SITE LOCATION: 302 East 5th Street**AGENDA ITEM: II.o****HISTORIC DISTRICT:** Houston Heights South**HPO File No. 140216****Owner:** Pablo Pereira, Unika Construction**Applicant:** Alex Ridgway, Brickmoon Design**Date Application Accepted:** 1/29/2014**90-day Waiver:** N/A**SITE INFORMATION:**

TYPE OF APPROVAL REQUESTED: Alteration – Removal of all original windows and exterior wall shiplap in contributing house (Revision to approved COA for two-story addition to one-story house)

CERTIFICATE OF APPROPRIATENESS

Engineer Letter

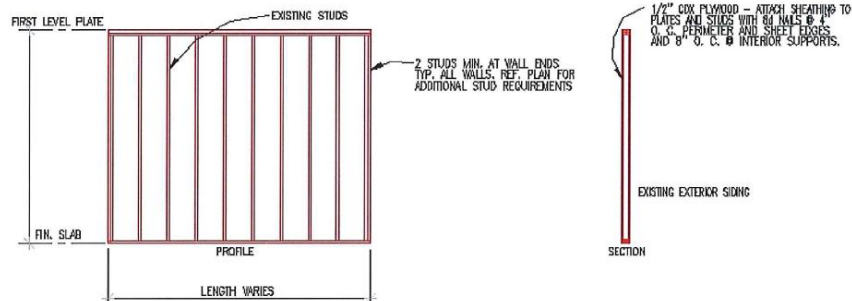
Since the ship lap was removed at the interior of the above referenced residence, plywood should be added to the walls and connected in accordance with the interior shear wall detail (shown below.)
